Product Change Notification

113273 - 00

Change Notification #: 113273 - 00
Change Title: Intel® Server System R2208GZ4GC
PCN 113273-00, Product Design
Update the System Rear Panel
Date of Publication: October 8, 2014

Figure One

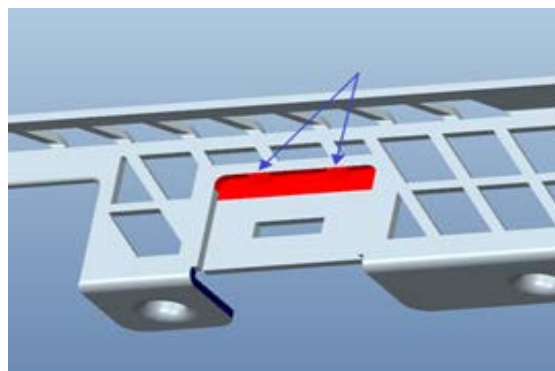
1. Update the one big center joint to two smaller joints so that the joints will not conflict with the LAN cable connector latch. See the Figure One.

Figure Two

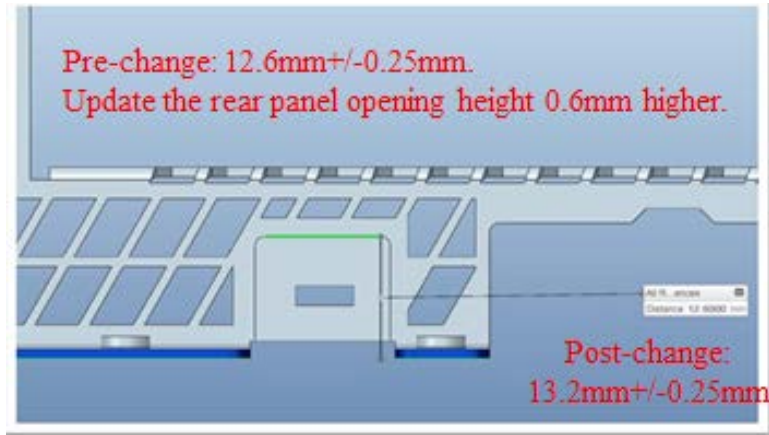
2. Update the rear panel opening height 0.6mm higher to improve the flexibility for the cable latch. The previous height was 12.6mm \pm 0.25mm. The updated height is 13.2mm \pm 0.25mm. See the Figure Two.

Figure Three

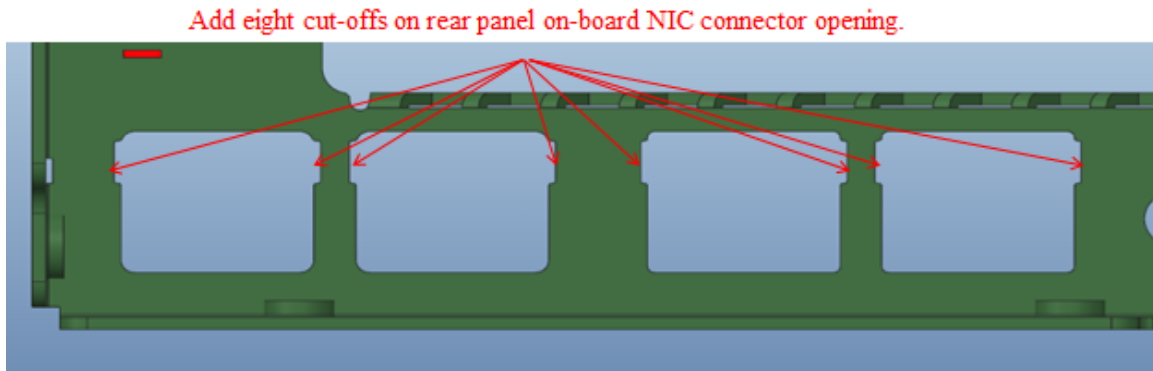
3. Add eight cut-offs around the on-board NIC (Network Interface Controller) openings to improve the LED visibility. See the Figure Three.
